ADDENDUM NO. One

Date: **September 29th, 2020**

Project Name: **Cepeda Branch Library Renovations**

C.I.P. No. **6014.041** Solicitation No.: **CSP6100 CLMC792**

OPENING SCHEDULES
& DETAILS

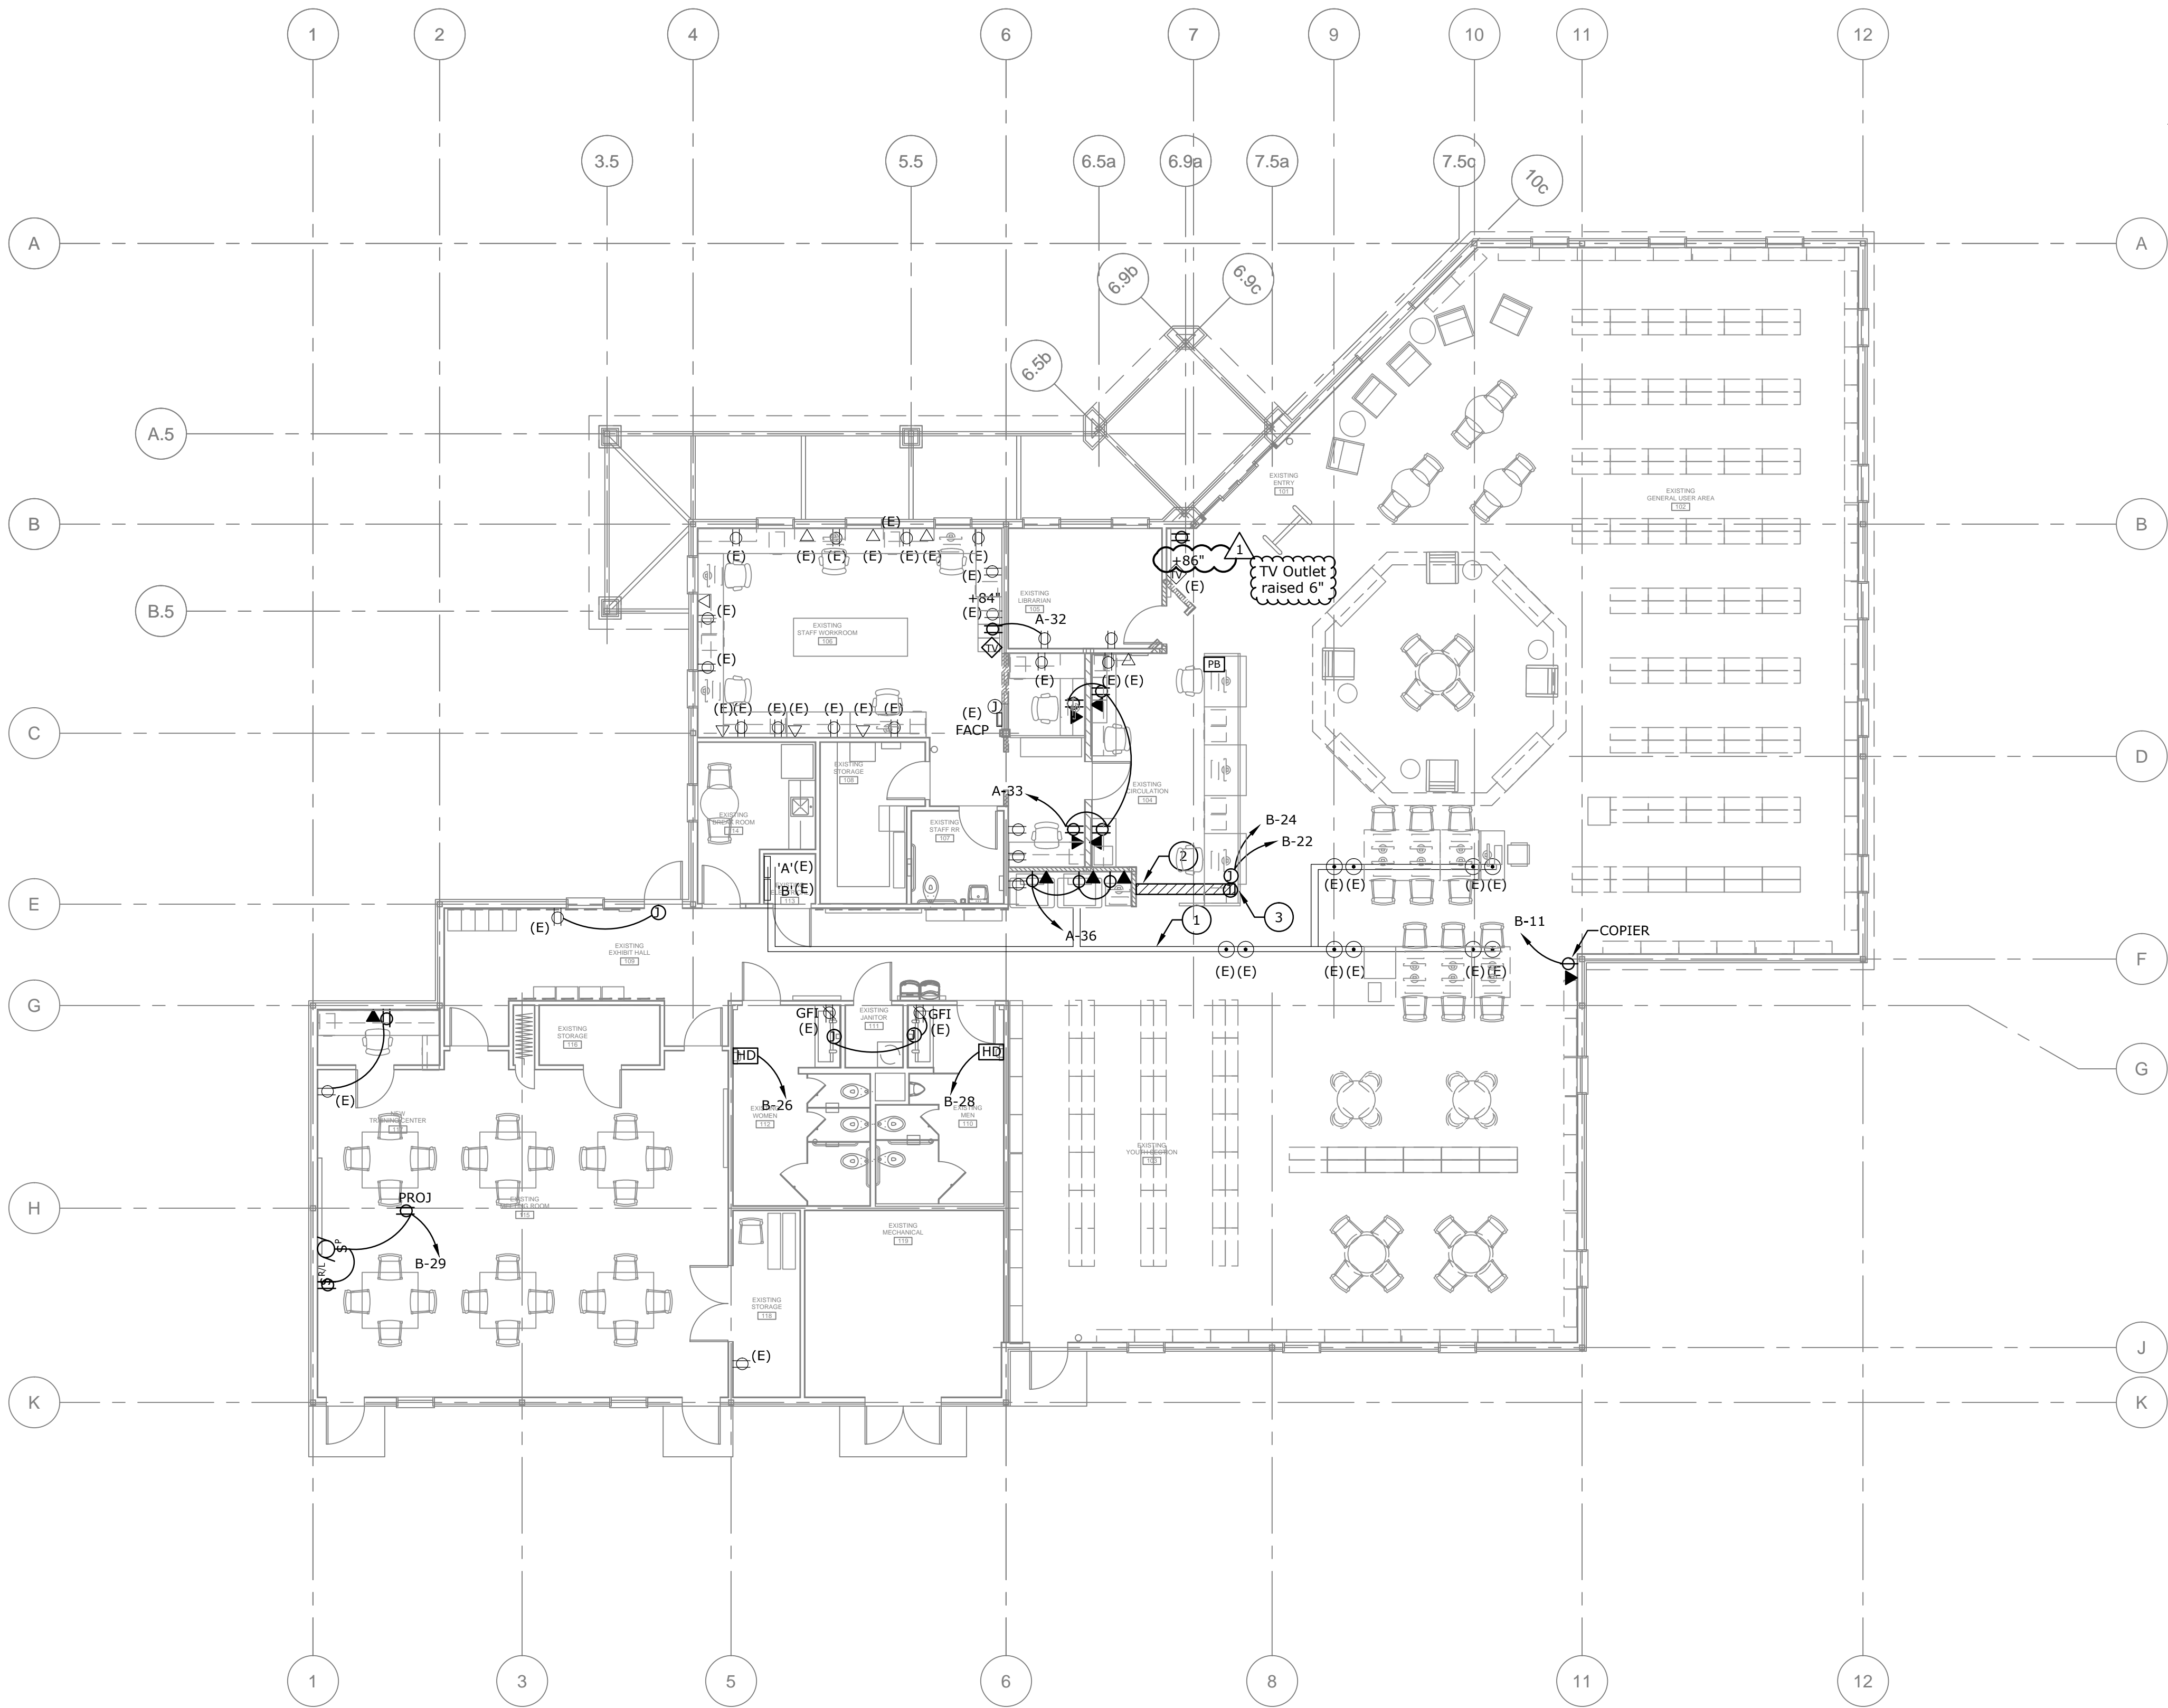
- Item 7. **On Sheet A-1.3 – Finish Plan & Schedules:** the drawing scale of the FINISH PLAN (1/A-1.3) is changed to 1/8" =1'-0" (from the former 1/16" =1'-0").
- Item 8. **On Sheet A-6.0 – Opening Schedules & Details:** the Door numbered 109A is removed from the DOOR SCHEDULE.
- Item 9. **On Sheet E-1.0 – Electrical Power Plan:** under KEYED NOTES: the note numbers 1, 2, and 3 are added.
- Item 10. **On Sheet E-2.0 – Electrical Lighting Plan:** the location of the New Lighting Control Panel is revised on the Plan (as per Keyed Note 1) and tagged Revision 1.
- Item 11. **On Sheet ED-2.0 – Electrical Lighting Demolition Plan:** the location of the existing Lighting Control Panel to be removed is revised on the Plan (as per Keyed Note 2) and tagged Revision 1.
